## **REMARKS**

### **AMENDMENTS TO THE DRAWINGS**

Please replace drawing sheets 3/12 and 9/12-12/12 with the attached replacement sheets 3/12 and 9/12-12/12 consisting of Figures 5, 6, and 12-16B.

FIG.5

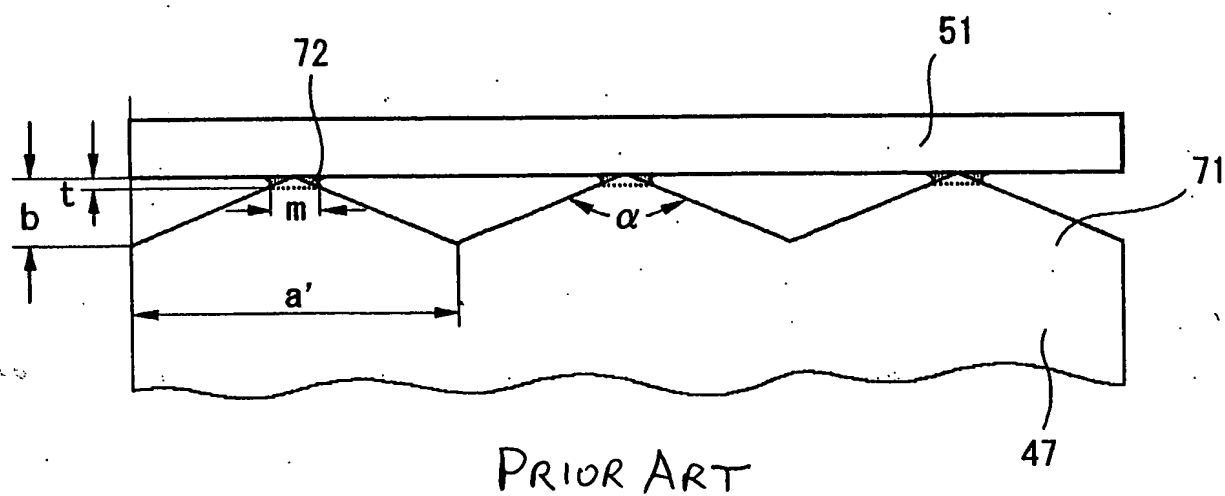
Applicant requests withdrawal of the objection to the drawings. Figures 5 and 12-16A have been amended to include the indication of "PRIOR ART" per the Examiner's recommendation. An indication of prior art has not been added to Figure 16B because Figure 16B relates to performance of the apparatus of the present invention. See e.g., paragraph [0044] in the Brief Description of the Drawings section of the specification.

Along with a replacement drawing sheets 3/12 and 9/12-12/12, a marked copy of these sheets showing the "PRIOR ART" additions to Figures 5 and 12-16A in red is included for the Examiner's approval.
